HISTORIC AND DESIGN REVIEW COMMISSION

Agenda Item No: 33

HDRC CASE NO: 2015-370
ADDRESS: 418 E MYRTLE
LEGAL DESCRIPTION: NCB 1752 BLK 5 LOT 14
ZONING: R6 H
CITY COUNCIL DIST.: 1
DISTRICT: Tobin Hill Historic District
APPLICANT: Gabriel Sanchez
OWNER: Gabriel Sanchez
TYPE OF WORK: Final approval of rehabilitation and construction of an accessory structure
REQUEST:

The applicant is requesting a Certificate of Appropriateness for approval to rehabilitate the primary historic structure as well as construct an accessory structure featuring 500 square feet at 418 E Myrtle.

1 SITE PLAN
SCALE: 1" = 10'-0"

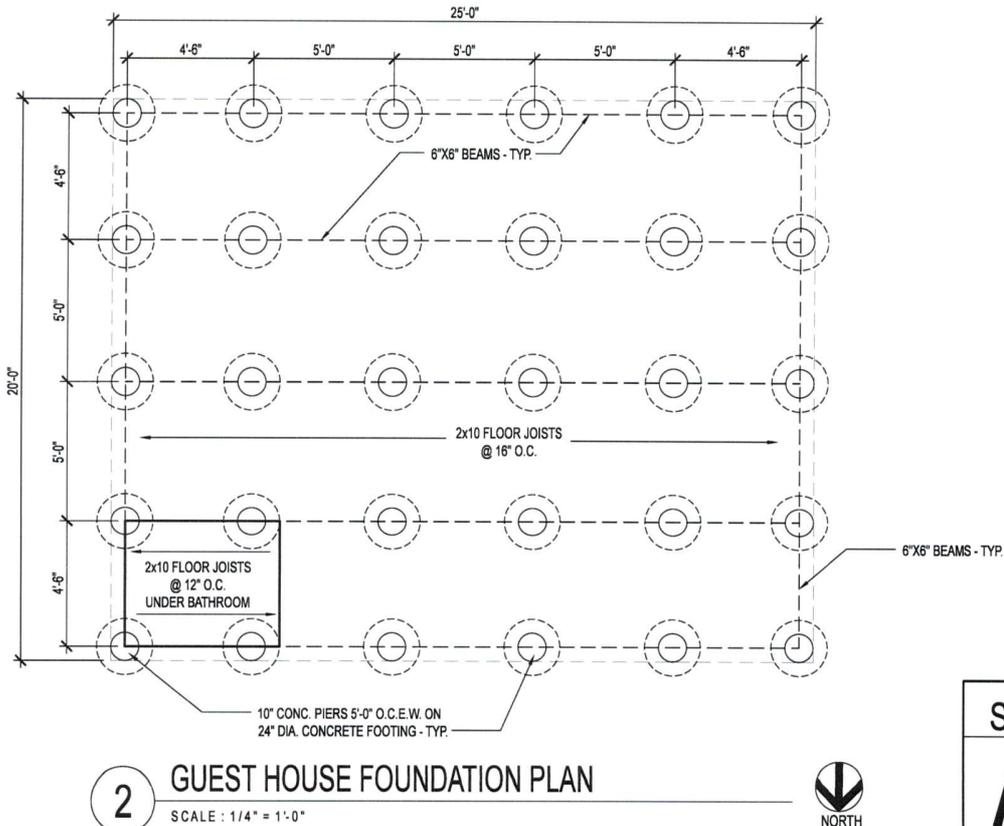
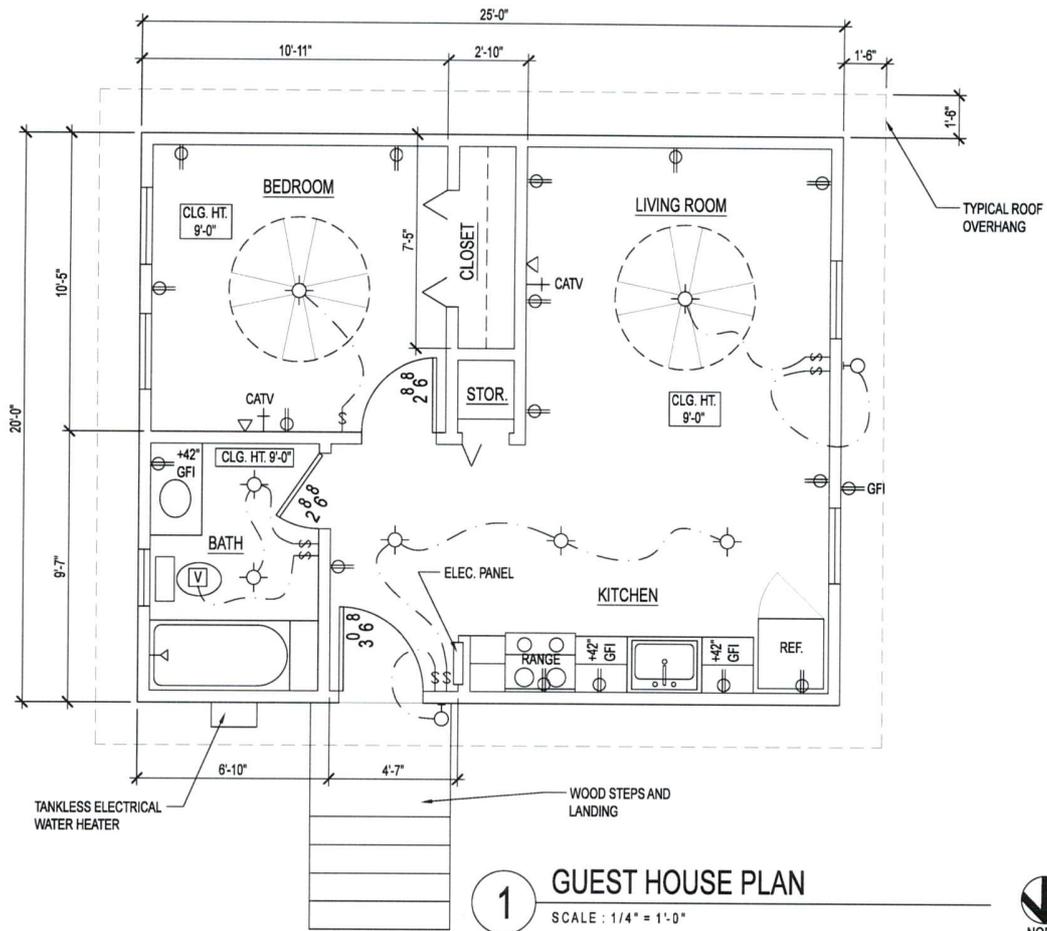
- b. Consistent with the precedent set throughout the neighborhood as well as the Guidelines for New Construction 5.B., the applicant has proposed to locate the accessory structure toward the rear of the property. While the applicant has adhered to a setback of ten feet, the precedent throughout Tobin Hill is to locate rear accessory structures at the rear property line. Staff recommends the applicant locate the proposed accessory structure at the property line and seek a variance.

- i. That the applicant install wood windows into the proposed accessory structure and primary historic structure.
- ii. That the applicant retain the existing window openings at the rear of the structure.
- iii. That the applicant located the accessory structure at the rear property line to be consistent with the historic example set in the neighborhood.
- iv. That the applicant install windows on the northern façade to address the lack of façade separation.

1 RENOVATION PLAN
 SCALE : 1/4" = 1'-0"

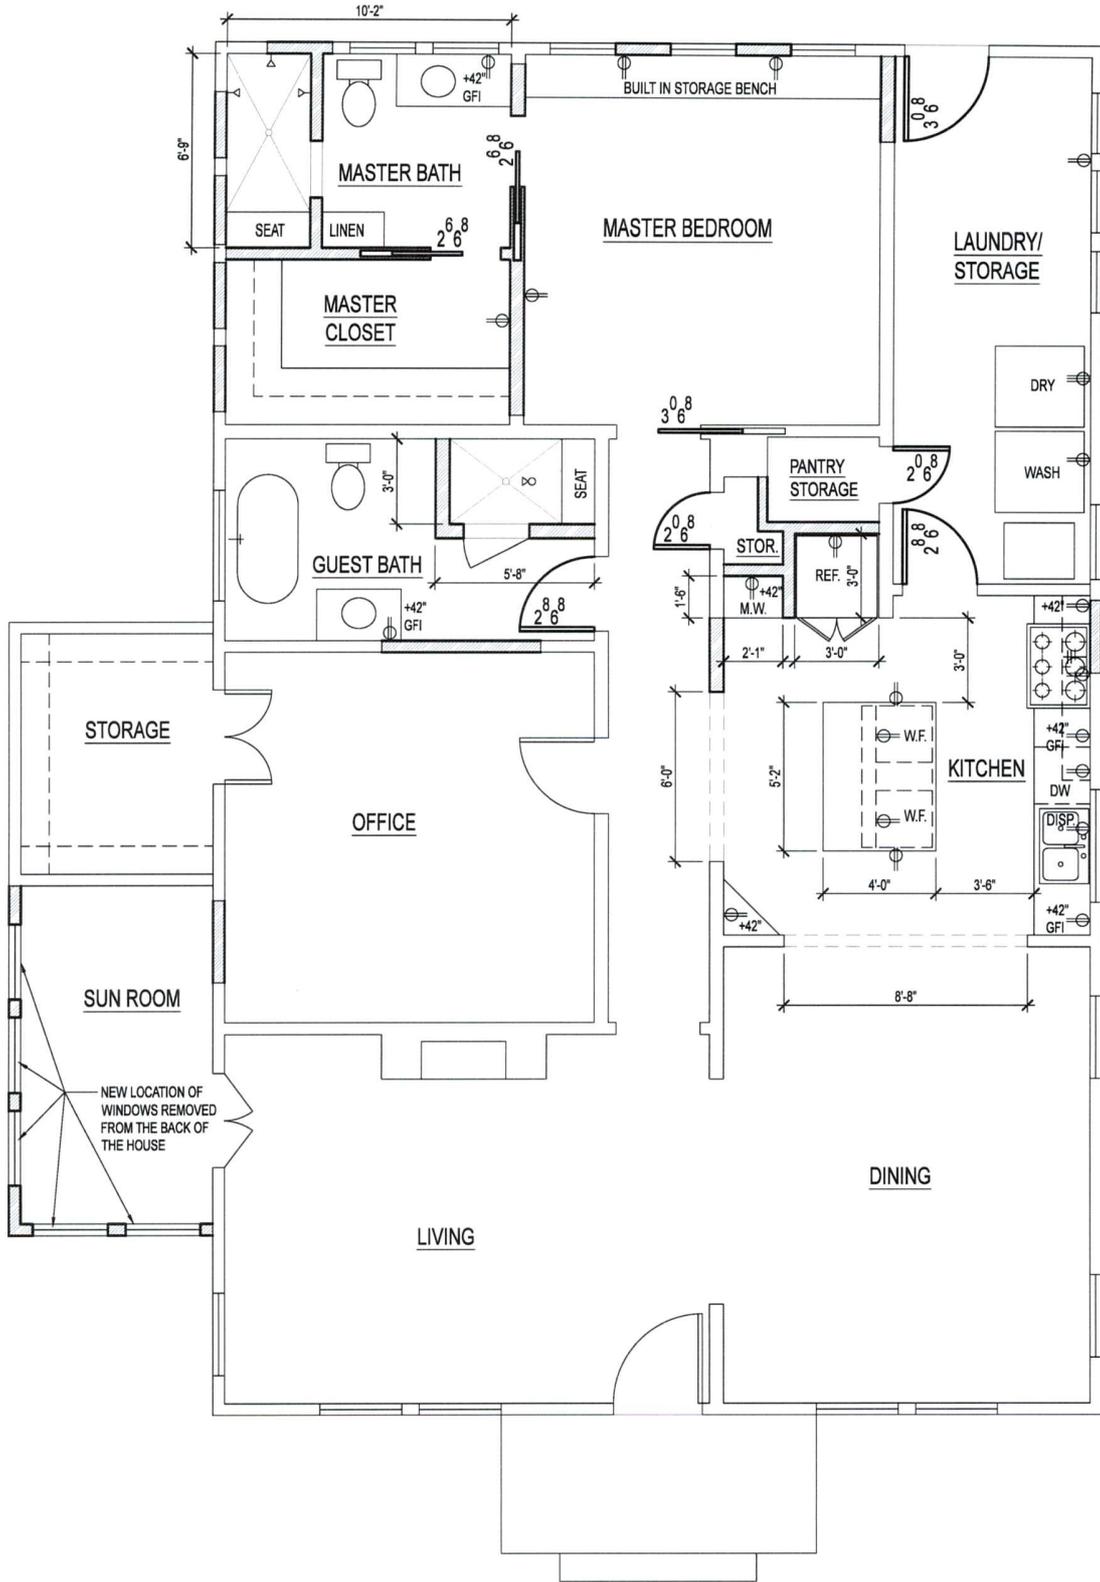
- d. On the east façade, the applicant has proposed to enclose non original open air porch. The applicant has proposed to relocate three existing wood windows from the rear of the house to the side where they will be incorporated into the closing of the non original open air porch. The Guidelines for Exterior Maintenance and Alterations state that existing window and door openings should not be enclosed. Staff finds that the relocation of the existing windows from the rear of the structure to the side is appropriate, however, the applicant should retain the existing window openings. Wood windows should be installed at both locations.
